**MEMORANDUM DATE:** April 4, 2022

**RE:** **403 4<sup>th</sup> Ave South**

**TITLE:** **HRPB Project Number 22-00100021:** Consideration of a Certificate of Appropriateness (COA) for window replacement in a building located at 403 4<sup>th</sup> Avenue South; PCN# 38-43-44-21-15-159-0070. The subject property is a non-contributing resource within the Southeast Lucerne Historic District and is located in the Mixed-Use Federal Hwy (MU-FH) zoning district. The future land use designation is Mixed-Use East (MU-E).

**Exhibit A: Window locations**

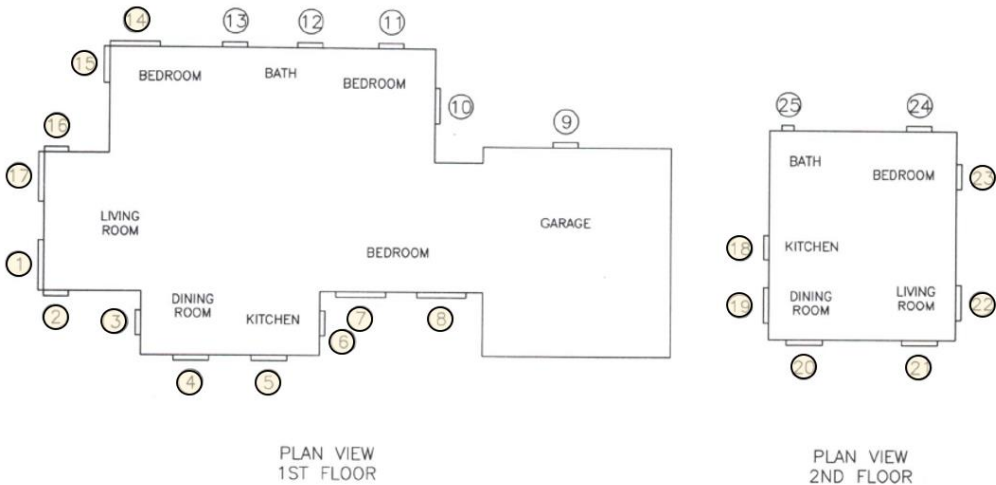
**STAFF RECOMMENDATION:** Staff is recommending denial of the proposed gray glass windows based on previous direction by the HRPB and the requirements in the Historic Preservation Design Guidelines. The proposed window locations are depicted in Exhibit A on pages 2 & 3. The applicant is requesting the following window specifications including:

**Staff Analysis:** The window replacements are depicted in the applicant’s drawings (see attachments). Based on the existing original windows and the City’s Historic Preservation Design Guidelines, staff contends that the replacement windows are appropriate provided the proposed windows successfully replicate windows appropriate for the architectural style. The use of gray glass has not typically been approved.

**Staff Analysis:** Based on the existing original windows and the City’s Historic Preservation Design Guidelines, staff contends that the proposal is *successful* in replicating the original window design. However, the proposed windows utilize gray glass, which has not been considered an appropriate replacement for clear glazing. The applicant has provided a justification statement included as an attachment.

**Staff Analysis:** The proposed gray glass is not visually compatible with the neighborhood character of the district and does not comply with the design guidelines.

- 1) The existing window trim, sills, and mullions shall remain. If any of these elements are too deteriorated for continued use, they shall be replaced in-kind, subject to staff review at permitting.
- 2) The windows shall be recessed within the wall, and shall not be installed flush with the exterior wall.
- 3) All divided-light patterns shall be created utilizing exterior raised applied muntins. Exterior flat muntins or “grills between the glass” shall not be permitted.
